Comments from Public Agencies

Comment Set A

TOWN OF COLMA
PLANNING DEPARTMENT

RE: Jefferson-Martin 230 kV Transmission Line Project DEIR

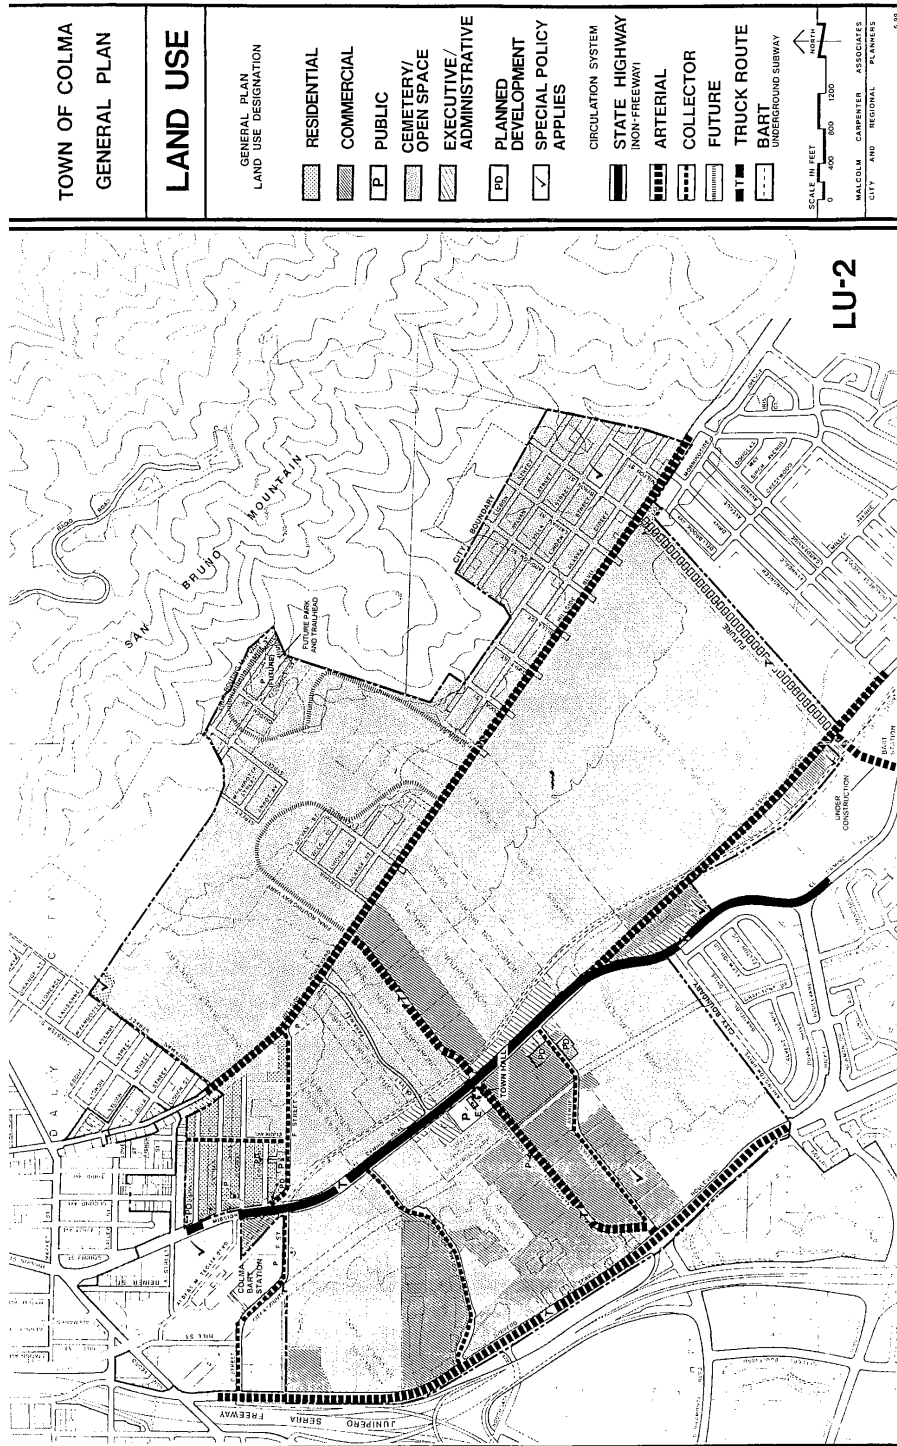
Lawndale Boulevard should be substituted for McLellan Drive on the map and in the Segment 3 Legend. The Colma General Plan land use has not been shown. A copy of the General Plan land Use Map is enclosed.

- A-8 The text within Section D.2.2.1, Town of Colma General Plan, and Figure D.2-2b, General Plan Land Use Designation (Northern Segment), have been revised in this Final EIR to note the correct street names, land use designations, and sensitive receptors.

Enclosure: Map Showing Project Locations

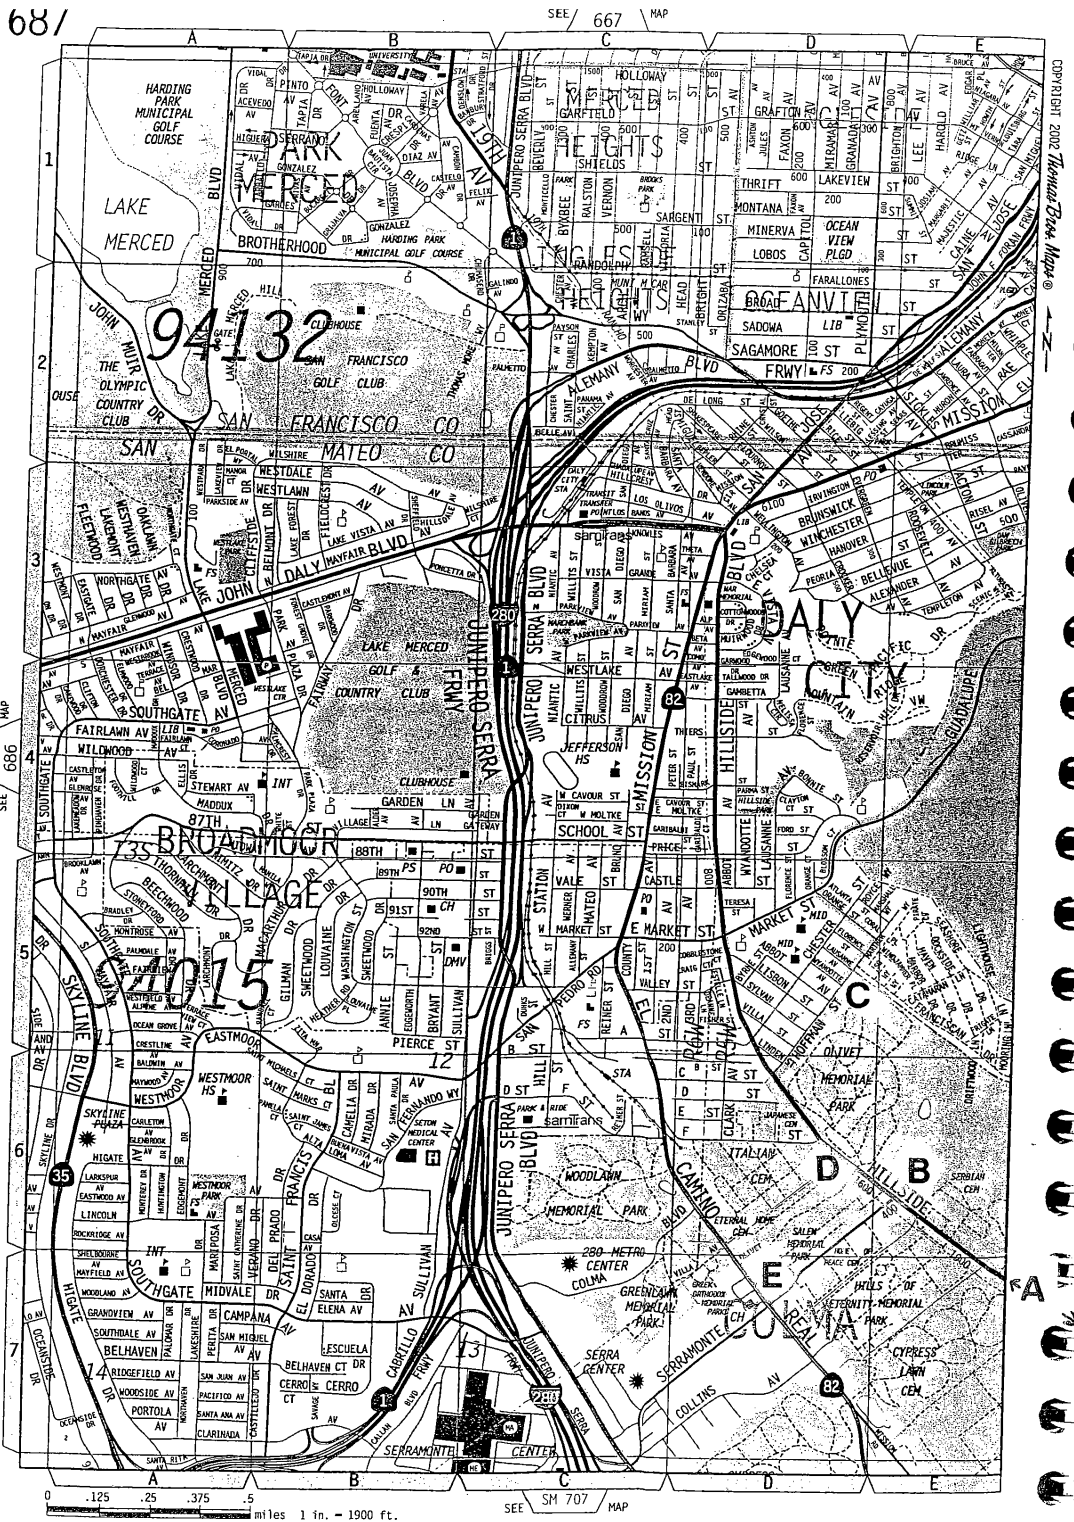
Development Projects in the Town of Colma. In your letter of February 7, 2003, you ask for a list of any current or pending projects within ½ mile of the proposed and alternative 230 KV routes. The following project locations are marked on the Thomas Brothers Map that accompanied your letter:

- **A** Hillside Boulevard Utility Under-grounding and Beautification (CIP project Scheduled to begin August 2003)

- **B** Cypress Lawn Hillside Boulevard Cemetery (Under construction)
- **C** Hoffman Court – 18 residential units (Under construction)
- **D** Hillside Community and Cultural Park (Under construction)
- **E** Colma Police Facility (CIP project scheduled to begin 2003)
- **F** Verano at Colma – 63 residential units (Under construction)

- A-21 The text in Table F-1, Cumulative Scenario – Approved and Pending Projects, has been revised in this Final EIR to include five Colma Capital Improvement Projects. In addition, Figure F-1b, Cumulative Project Locations – Northern Segment, has been revised to incorporate the additions to the table.
